UNITED STATES DEPARTMENT OF THE INTERIOR BUREAU OF LAND MANAGEMENT

OCD Artesia **SUNDRY NOTICES AND REPORTS ON WELLS** NMNM92177 Do not use this form for proposals to drill or to re-enter an

Conditions of Approval

COG Operating LLC JR's Horz Federal -1 API 30-015-33066 T26S-R29E, Sec 10 November 3, 2012

Current and proposed schematics are attached.

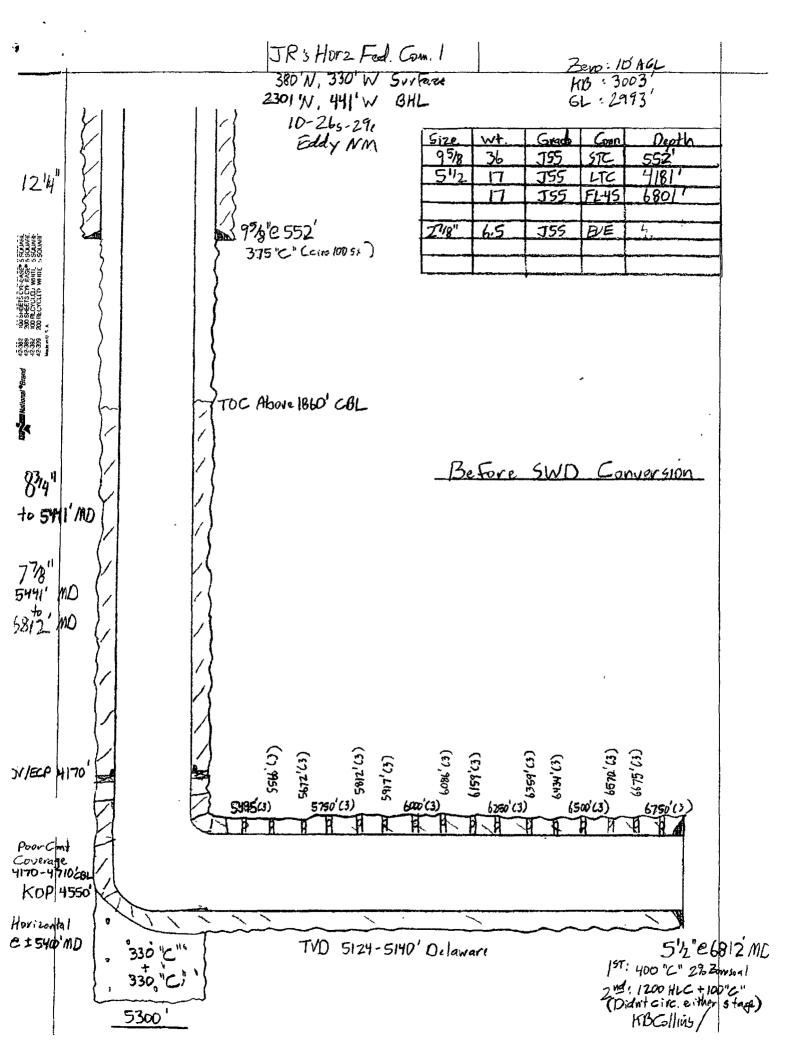
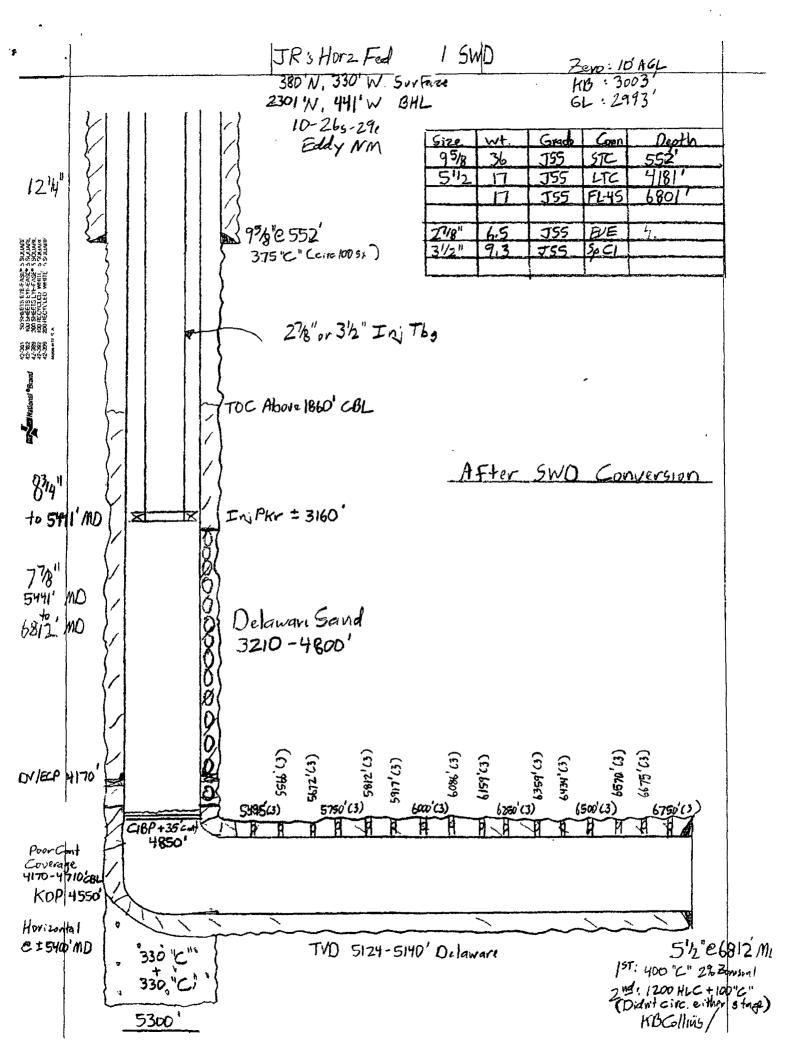
- 3. Provide BLM with an electronic copy (Adobe Acrobat Document) cement bond log record from 5200' or below to top of cement. The CBL may be attached in an e-mail to pswartz@blm.gov. The CFO BLM on call engineer may be reached at 575-706-2779. The CBL shall be reviewed prior to placing cement on the proposed CIBP.

- Step 1. Set the CIBP at approximately 5050'. Test the CIBP and casing to 1000 psi to verify a seal. This test shall be witnessed by the BLM, charted and a copy of the chart included with the Subsequent Report sundry. Once a seal has been verified, place a 25 sack neat Class C cement plug on the CIBP. The BLM PET witness is to run tbg tally and agree to cement placement. Sample each plug for cement curing time and tag and/or pressure test (WOC time of 4 hours recommended) as requested by BLM PET witness.
